Proposal for Supplement 6 to the 06 series of amendments to Regulation No. 16 (Safety-belt)

The modifications to the existing text of the Regulation are marked in bold for new or strikethrough for deleted characters.

"Figure 2
Installation of fixture onto vehicle seat
(see paragraph 2.6.1.)

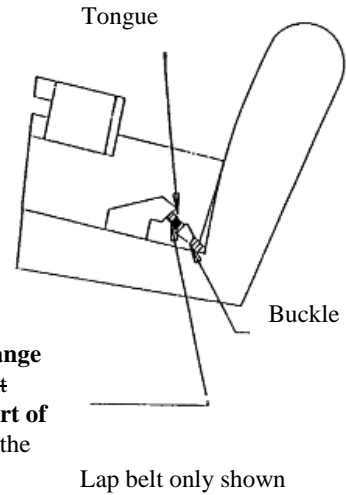
Annex 17, Appendix 1, Figures 2 and 3, amend to read:

Note: Within the adjustment range of the seat belt, the webbing must shall contact, at a minimum, part of the curved edge on both sides of the fixture.

Figure 1: Positioning of Fixture

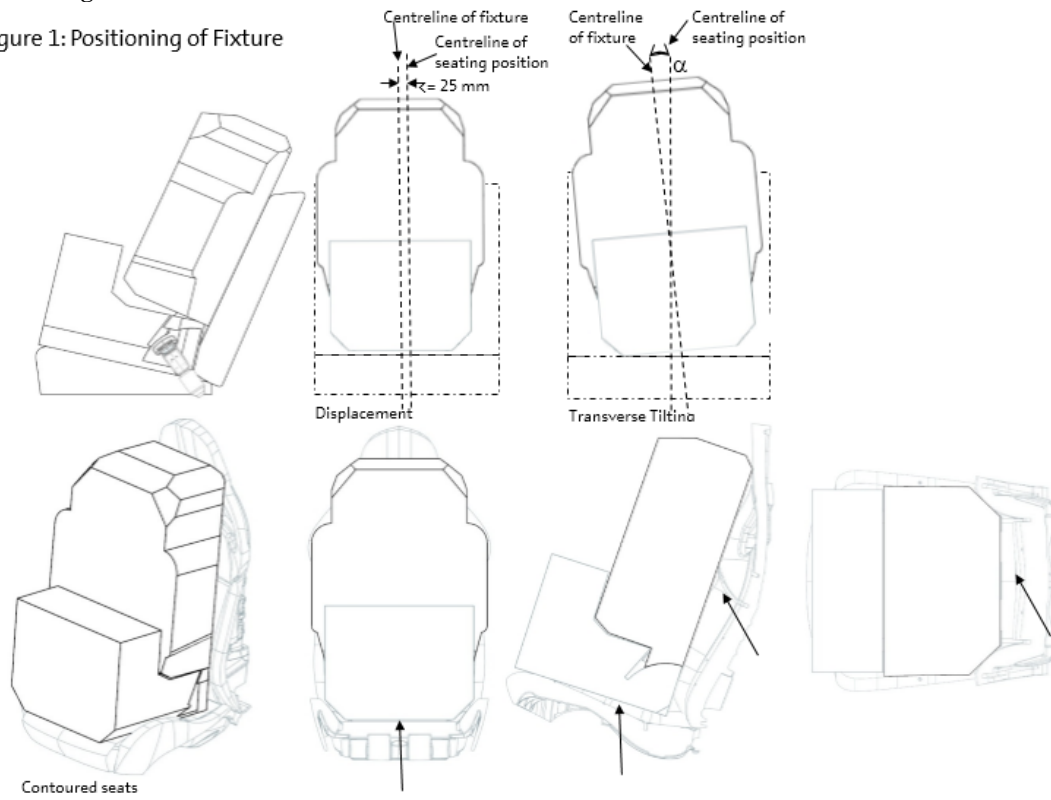
- 3.2. The roll angle as shown in Figure 1 shall be equal to or less than $[5^\circ]$.
 - 3.3. The base of the fixture shall be in contact with the seat cushion, and the back face of the fixture shall be in contact with the seat back or head restraint. Full contact with the seat is not necessary, "gaps" due to the vehicle seats contours are permitted as shown in Figure 1.

Figure 2 Belt Buckling

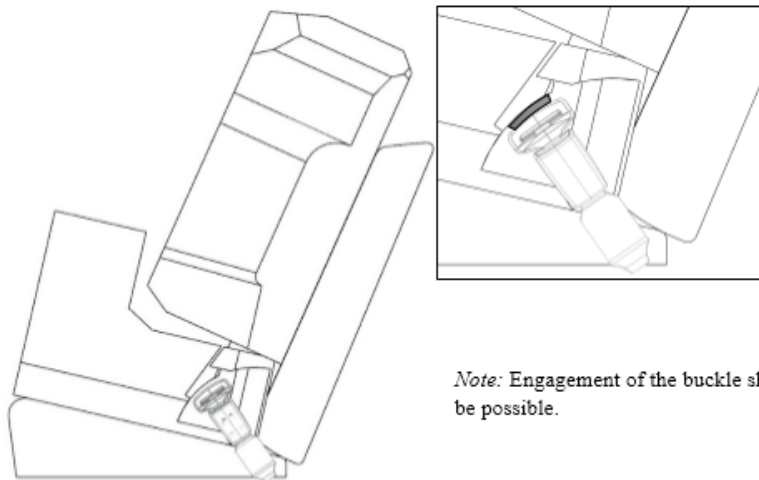
3. Requirements
 - 3.1. It shall be possible to secure the fixture in the seating position using the 3-point seat belt and to buckle up the seat belt. The lap portion of the belt shall touch the fixture on both sides at the rear of the lap belt path (see Figure 2).

Note: Engagement of the buckle shall be possible.

Universal Booster Seat Fixture: without ISOFIX, or with anchorages removed or stowed within the body of the fixture (behind line E, as defined by detail B).

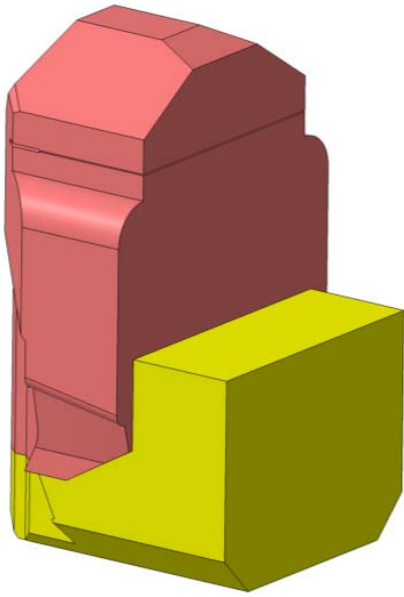
"8.3.7. Any Universal booster seating position shall allow the installation of the universal booster child restraint fixtures as defined in Annex 17, Appendix 5 –ISO F4, without ISOFIX attachments (see detail B).

To update: Complete 135 cm CRF

cushion only CRF"

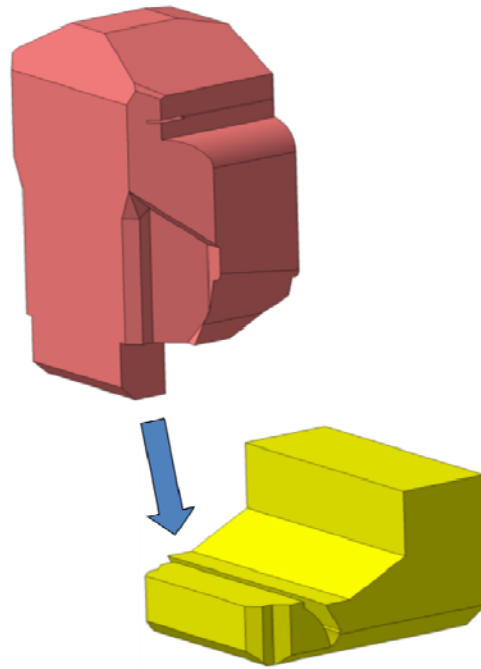
- 3.5. Where the 135cm CRF cannot be installed, then install the booster cushion CRF (lower part of the figure2) following the above procedure.
4. The fixture below shall be constructed with a mass of 10 kg +/- 5kg and shall be of suitable durability and stiffness to satisfy the functional requirements.
